**AGENDA**  
**HAILEY PLANNING & ZONING COMMISSION**  
*SPECIAL MEETING*  
**Monday, September 28<sup>th</sup>, 2015**  
**Hailey City Hall**  
**5:30 p.m.**

**MINUTES OF THE  
HAILEY PLANNING & ZONING COMMISSION  
Monday, September 14<sup>th</sup>, 2015  
Hailey City Hall  
5:30 p.m.**

**FINDINGS OF FACT, CONCLUSIONS OF LAW AND DECISION**

**TO:** Hailey Planning and Zoning Commission

# Revised Site Plan

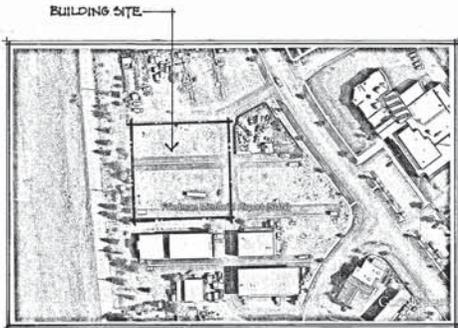
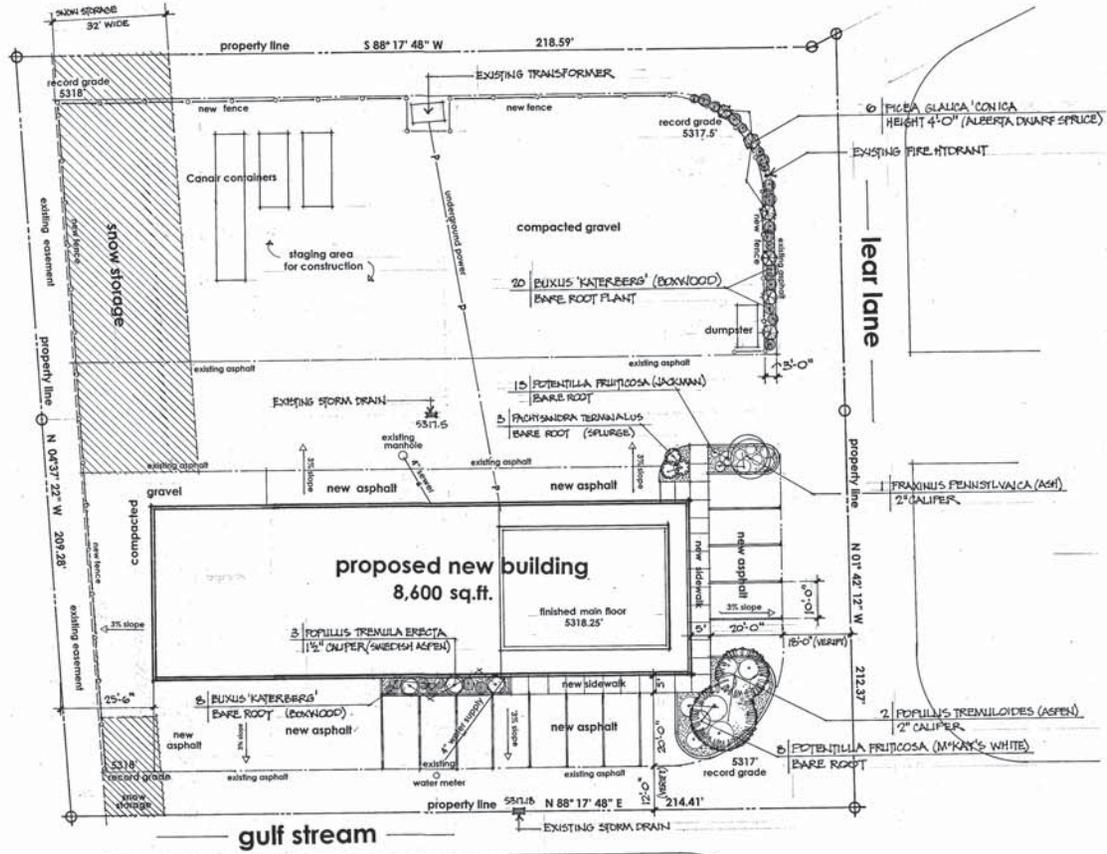
<i>Staff Comments</i>	<i>Snow storage has been relocated to the NW and SW corners of the lot. Staff has advised the applicant to modify snow storage to be placed within the fencing.</i>
<input checked="" type="checkbox"/>	<input type="checkbox"/>	<input type="checkbox"/>	6A.8(A)1j	<p><b>j. Snow storage areas shall not be less than 25% of the improved parking and vehicle and pedestrian circulation areas.</b></p>
			<i>Staff Comments</i>	<i>Parking/Pedestrian &amp; Circulation: <del>18,700 sq. ft.</del> 17,164 sq. ft.                  Snow Storage required: <del>4,675 sq. ft.</del> 4,291 sq. ft.                  Snow Storage provided: <del>4,700 sq. ft.</del> 4,336 sq. ft.</i>
<input checked="" type="checkbox"/>	<input type="checkbox"/>	<input type="checkbox"/>	6A.8(A)1k	<p><b>k. A designated snow storage area shall not have any dimension less than 10 feet.</b></p>
			<i>Staff Comments</i>	<i><del>Snow storage is 24' wide.</del> Snow storage varies in width but is no less than 10 feet in width.</i>

Revised Elevations

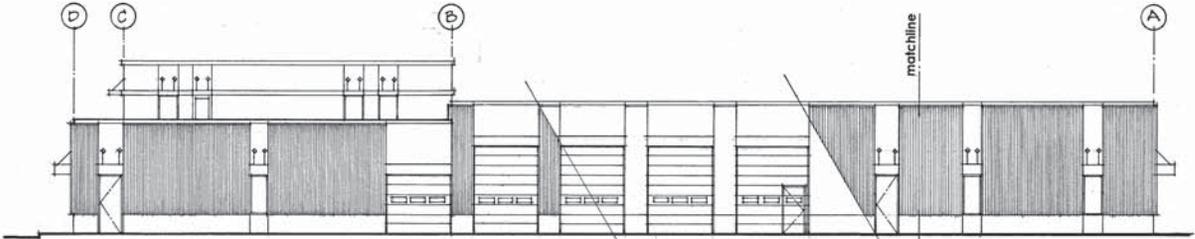
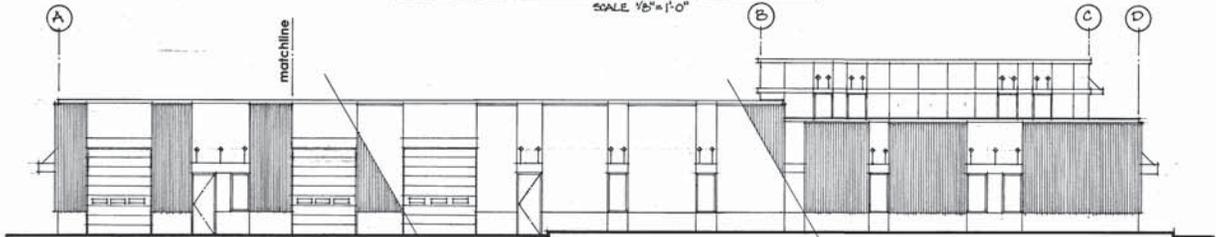
Design Review modification application for an additional 1,536 sq. ft. to increase the total proposed building floor plan to 8,600 square feet. Applicant has indicated that the owner plans to increase the footprint of the building 32’ extending towards the west property line. All proposed materials shall remain the same as follows: stucco, corrugated steel wall panels, metal clad wood windows, rolled steel wall panels, and steel ‘C’ channel awnings.
